## **KELLY TRUST SUBDIVISION**

APPLICATION NUMBER 4 DATE December 6, 2018

REQUEST Subdivision

# DETAIL SITE PLAN

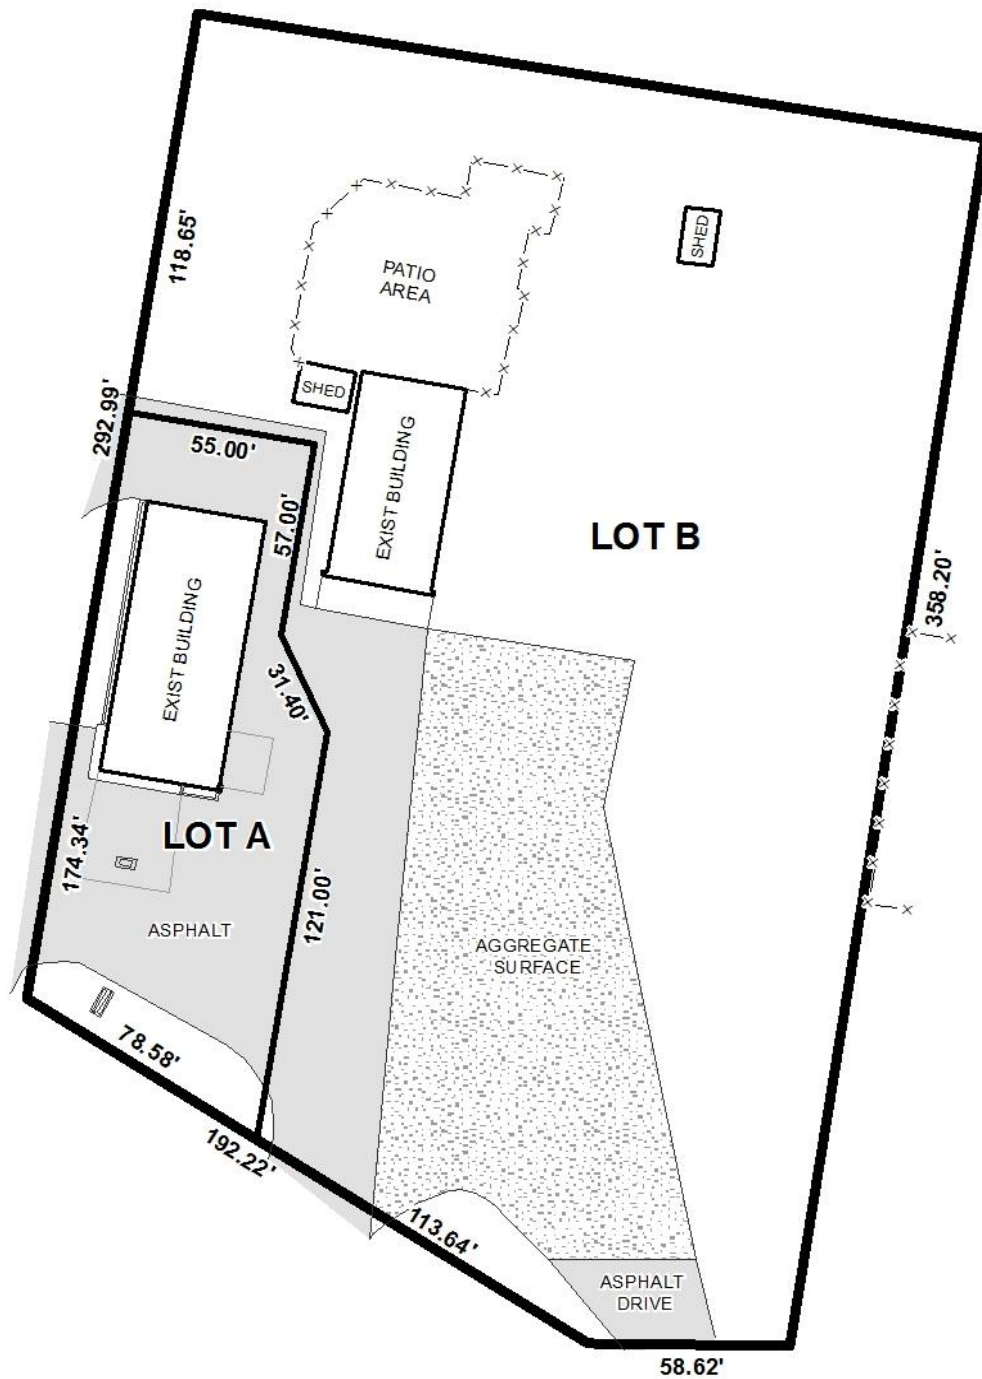
The proposed lot fronts Dauphin Island Parkway, a major street on the Major Street Plan, and Pillans Lane, and Rosedale Road, both minor streets. The preliminary plat illustrates a compliant 120' right-of-way width on Dauphin Island Parkway. If approved, the right-of-width should be retained on the Final Plat. The preliminary plat illustrates a 30' right-of-way width on Pillans Lane. A 50' right-of-way width is required. If approved, the Final Plat should be revised to illustrate additional setback to provide 25' from the centerline of Pillans Lane. It should be noted that the Schultz Subdivision to the North in 1990 only appears to have required 10' dedication to Pillans Lane and the Wright Transportation Subdivision to the West in 2015 did not require any dedication to Pillans Lane. The preliminary plat illustrates a compliant 60' right-of-way width to Rosedale Road and, if approved, should be retained on the Final Plat.

It should be noted that there are at least two primary structures on the subject site. The preliminary plat does not provide building setbacks. Though developed commercially, the subject site is zoned R-1, Single Family Residential and therefore requires a 25' minimum building setback along Dauphin Island Parkway. Because the subject site is a corner lot, a 20' side yard setback would typically be required along Pillans Lane. This results in an existing building that encroaches in a required sideyard setback and right-of-way. However, Staff finds that GIS data confirms the property in its current configuration for 40+ years and therefore, the setbacks may be considered non-conforming. If approved, provision of a 25-foot minimum building setback line along Dauphin Island Parkway and a 20-foot minimum building setback line along Pillans Drive will be required on the Final Plat. Due to the subdivision of the land, and the fact there is no non-conforming or variance records of the site, a rezoning application will be required to rezone the property to allow commercial uses.

- 1) Retention of the 120' right-of-way width to Dauphin Island Parkway;
- 2) Revision of the plat to depict a minimum building setback line to be at least 45 feet from centerline for Lot A;
- 3) Revision of the plat to reflect dedication to provide 25' from the centerline for Lot B, plus a 20' minimum building setback;

- 4) Retention of the 60' right-of-way width to Rosedale Road;
- 5) Provision of a 25' minimum building setback line along Dauphin Island Parkway;
- 6) Provision of a 20' minimum building setback line along Pillans Lane,
